Electro Magnetic Interference Testing and Engineering

August 8, 2002

Joe Dichoso
Federal Communication Commission

Reference: LDK102045
Correspondence number: 23502
Applicant: Cisco Systems Inc.

Photo 1: Test setup for the measurements made with the Spectrum Analyzer

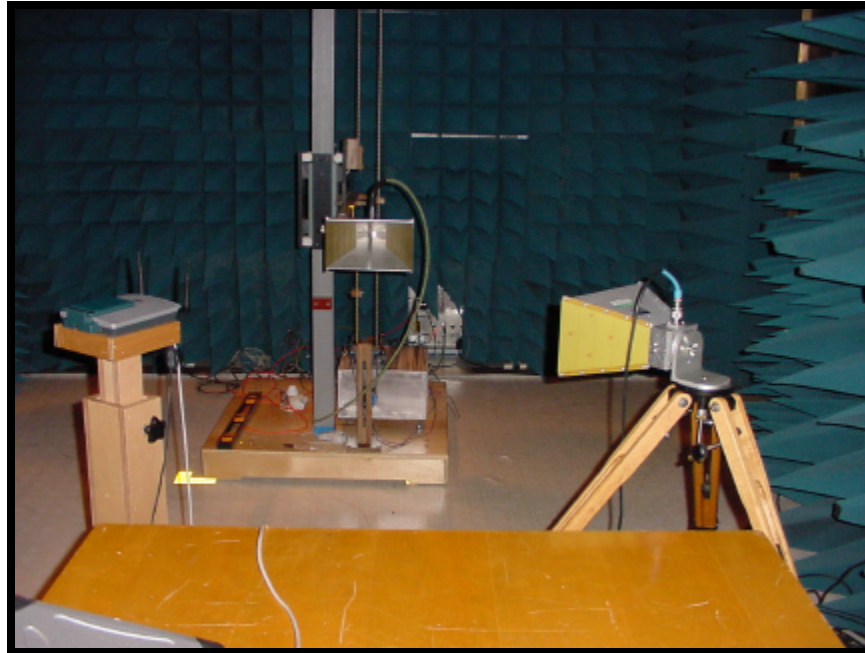
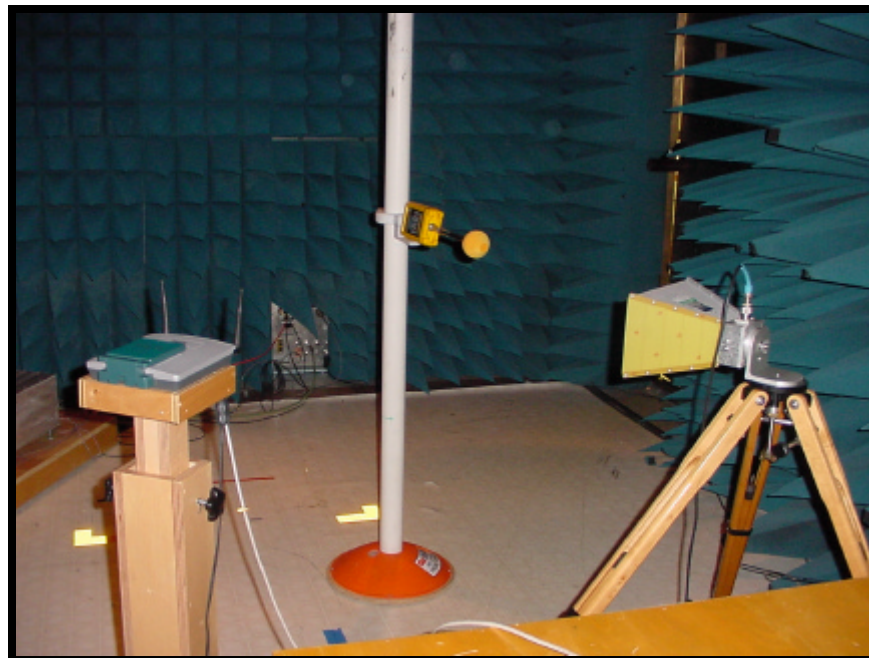
13) MPE please confirm/demonstrate that probe responds correctly to device modulations. Some modulations and amplitudes can cause diode probes to over or under estimate actual rms field strength levels

14) MPE please confirm/demonstrate that probe responds correctly to simultaneous 2.4 and 5.25 GHz signals. Multiple signals with some diode probes can over or under estimate actual rms field strength levels

To investigate the influence of signal modulation on the EMR-200 measurement results the substitution method was chosen. Namely: measurement with a standard receiving horn antenna/ Spectrum analyzer, and the EMR Isotropic measurement unit. First set of measurements was performed with the EUT transmitting in CW mode and 100% duty cycle modulation mode to a receiving horn antenna connected to a Spectrum Analyzer (Model 8564E). This antenna (Electro-Metrics, Model RGA, 1-18GHz) and the EUT was placed 20 cm away from each other and at a height of one meter. A second set of measurements was performed with the EMR-200 measurement unit; its isotropic probe was placed on the same position and height as the receiving antenna in the first measurement. All equipment with exception of the Spectrum Analyzer was placed in the anechoic room.

The probe was investigated to determine its response when multiple signals at the same or different frequencies were present with the substitution method in an anechoic room. Two signal sources were used: One was the EUT configured to transmit in the un-modulated mode, and the second was a 5 GHz generated signal from a signal generator (HP, Model 83752A) and transmitting horn (Electro-Metrics, Model 3115, 1-18GHz) configuration. First set of measurements was performed with the Spectrum Analyzer connected to the receiving horn antenna (both, the analyzer and the antenna are described in question 13 of the FCC's response. The second set of measurements was made with the EMR-200, placed in the same position and height as the receiving horn antenna configuration from the first set of measurement. Then the results of two sets of measurements were compared. The test setups photos are shown below. All other equipment except the Spectrum Analyzer was placed inside the anechoic room. Note: Spectrum Analyzer settings was Rbw/Vbw = 1MHz including a span that includes both signals set at 5 GHz. A 4 GHz measurement bandwidth was used in the Power density measurement mode. For the EMR-200 measurements calibration factor of 1 for both frequencies was used.

Photo 2: Test setup for the measurements made with the EMR-200
